## Installation Monitoring Report

**Date:** October 9, 2025

<b>Project</b>	NW 2050 Cypress Point	<b>Job Number</b>	24064	<b>RGC Number</b>	53216		
<b>Address</b>	7511, 7531, 7651 Minoru Boulevard	<b>Inspector</b>	Matthew	<b>Report Number</b>	50		
	Richmond, B.C.	<b>Weather</b>	Cloud / 19°C	<b>Time</b>	11:45am		
<b>Contractor</b>	Flynn Canada Ltd.	<b>Crew Size</b>	0	<b>Red Seal</b>	0	<b>Apprentices</b>	0

**50.1 Building A, unit 307**

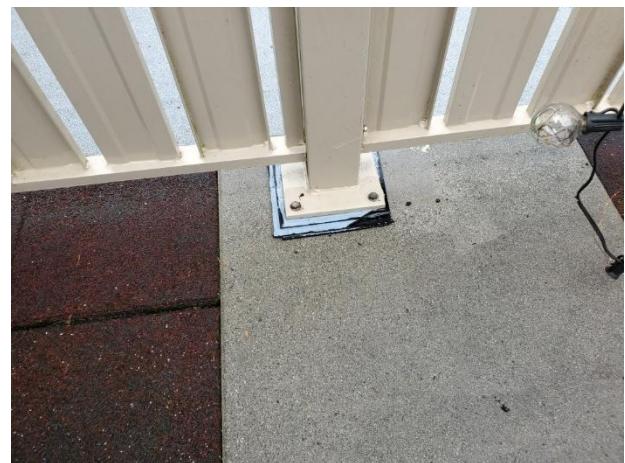
Pavers still remain to be leveled around drain location.
